Department of Public Works – Stormwater Section
El Paso County

Re: Space Village Road Outdoor Storage; PPR233, CON2429, ESQ2430

Stormwater Detention and Infiltration Design Data Sheet

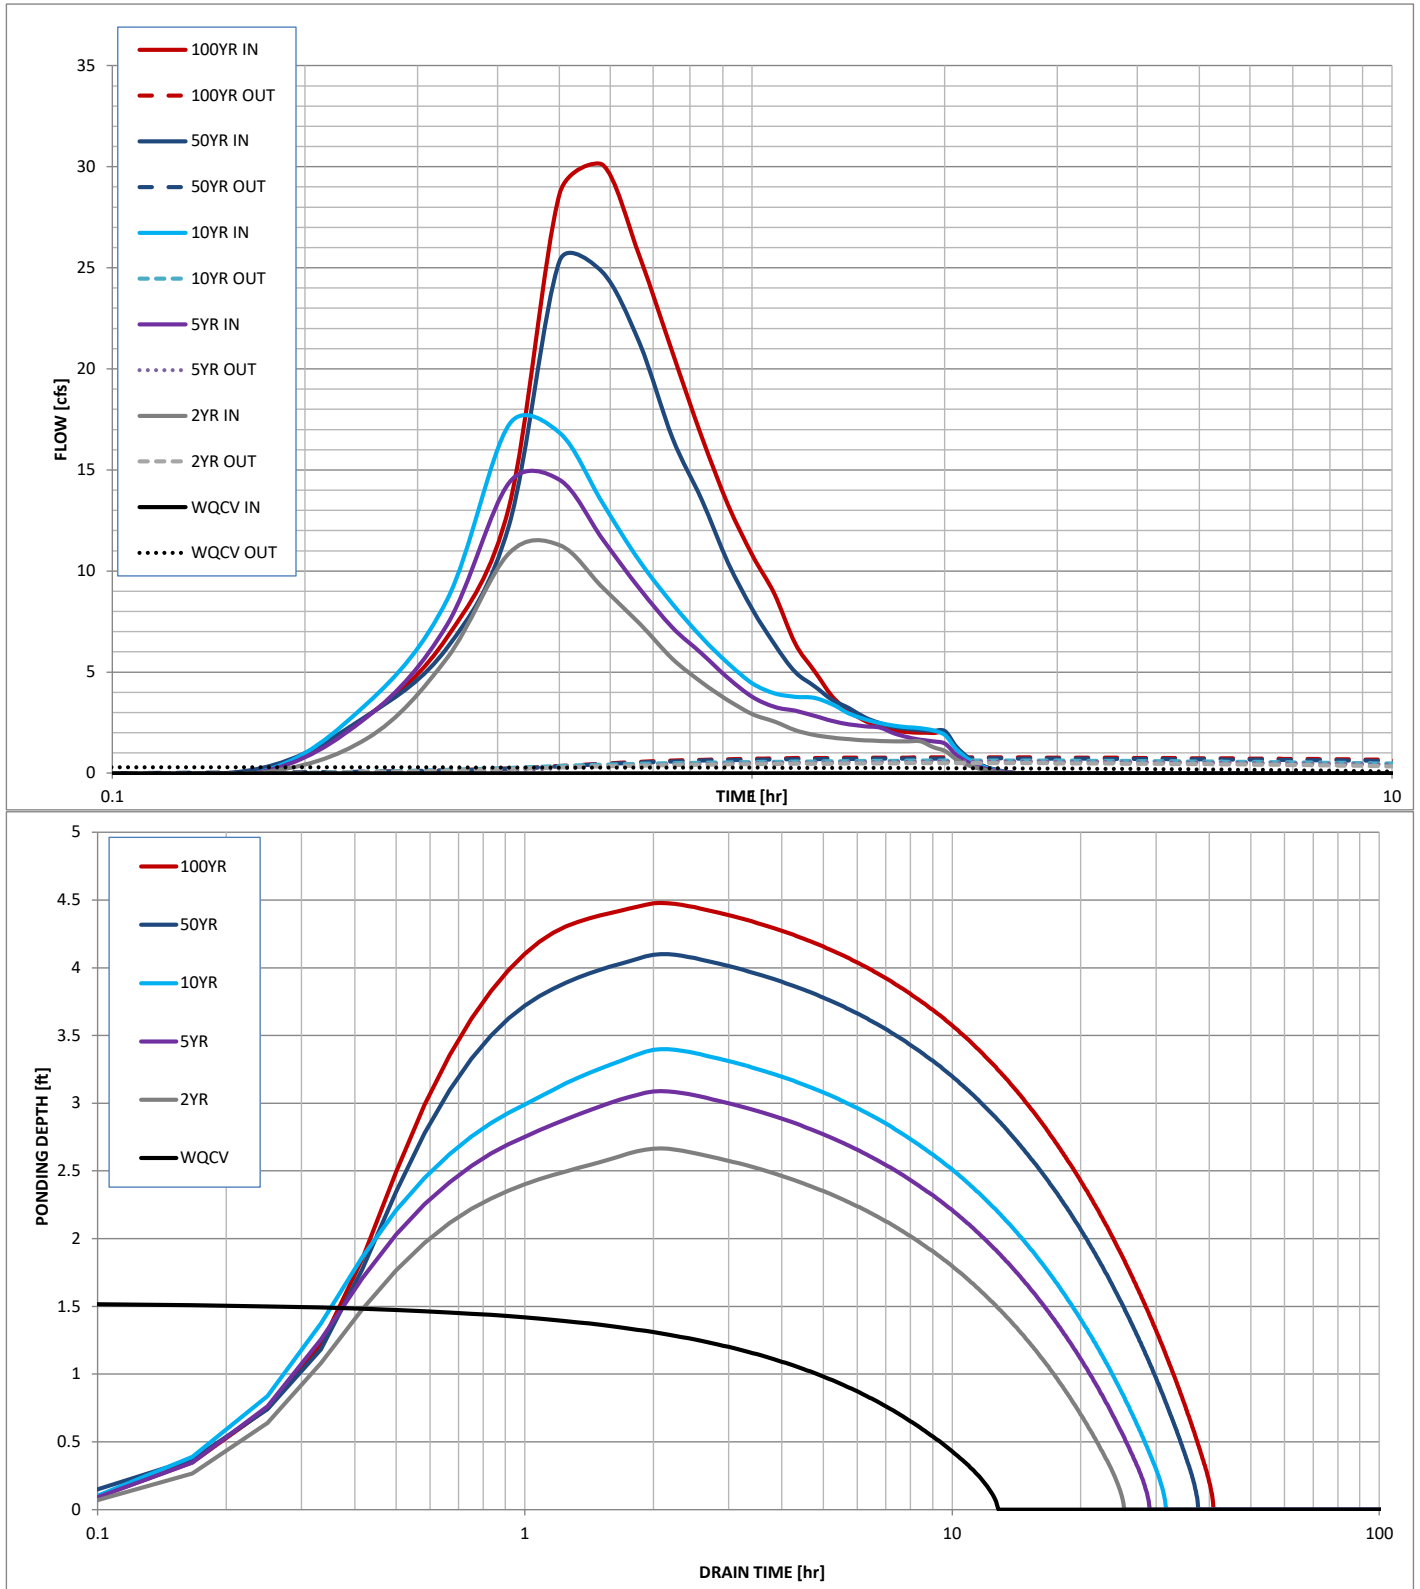
As-builts show a 3.31' depth from
spillway crest to basin bottom.

The West pond has been revised. The depth from pond bottom to spillway crest has been revised on both the SDI sheet and the plan asbuilts.
